Subject: HNDC HN-100 Series 1  
Radioactive Materials Package  
Certificate of Compliance No. 71-9086  
Application for Renewal

Radioactive Materials Package  
 Certificate of Compliance No. 9086  
 HNDC Model HN-100 Series 1  
 Application for Renewal

"Responses to Nuclear Regulatory Commission Letter  
 Dated November 29, 1982"

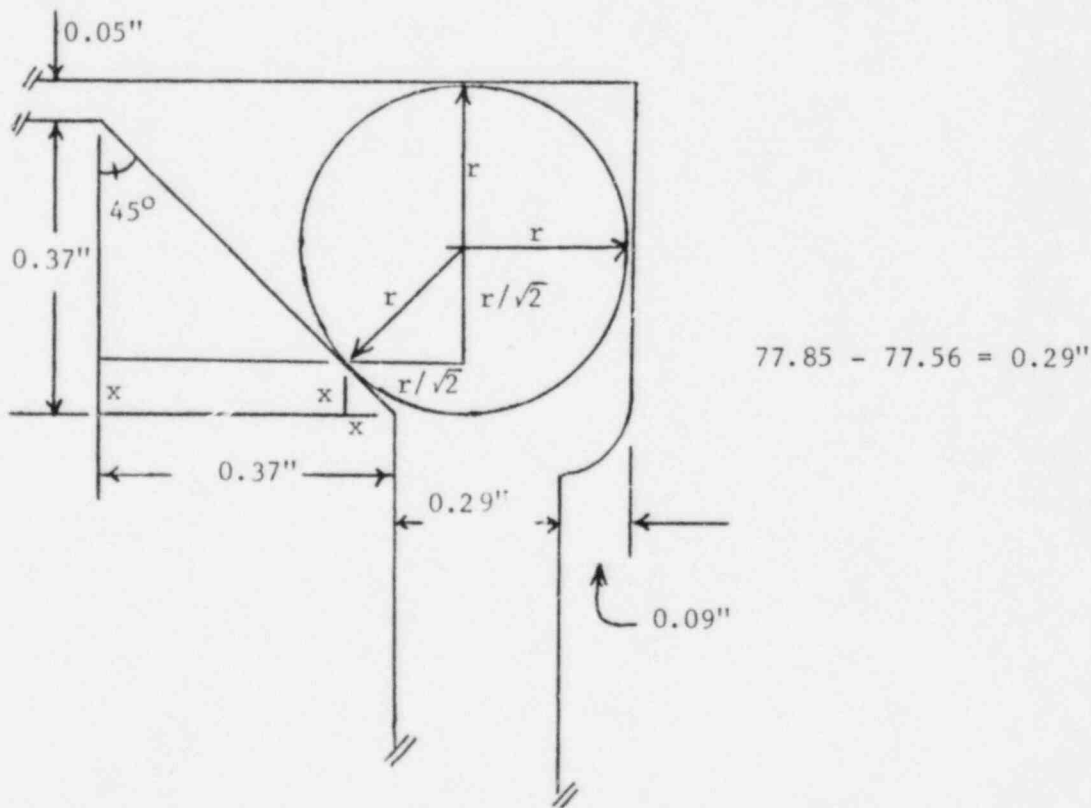
- 1a. Sealing of the cask during closure is accomplished by an O-ring gasket on the primary and secondary shield covers. The minimum offset of the lid which could cause ununiform seating on the gasket is the tolerance on the metal to metal contact of either the lid and cask body, or primary and secondary lid. The maximum opening on the primary lid is the difference in O.D. of lid and I.D. of body.

$$\begin{array}{rcl} r + r/\sqrt{2} & = & 0.09 + x \\ r + r/\sqrt{2} & = & 0.03 + 0.37 - x \\ \hline 2r + \sqrt{2}r & = & 0.49 \end{array}$$

$$3.414 r = 0.49$$

$$r = 0.1435$$

$$\text{diameter} = 0.287 \text{ inches}$$

The gasket used is 1/2 inch diameter; this would give a maximum compression of 42%.

By tightening the 30 one inch studs from 190 to 210 ft-lbs, the compression ranges between 6% and 42%. These values are in the cask handling procedure which is part of the Rad Services Manual furnished to each user. This range between 6% and 42% compression assures maintaining a seal at the maximum displacement and does not excessively crush the O-ring and cause permanent damage.

The shield plug may be shifted as much as 1/32 inches in the stud holes. The compression ranges from a minimum 22% to a maximum 51%.
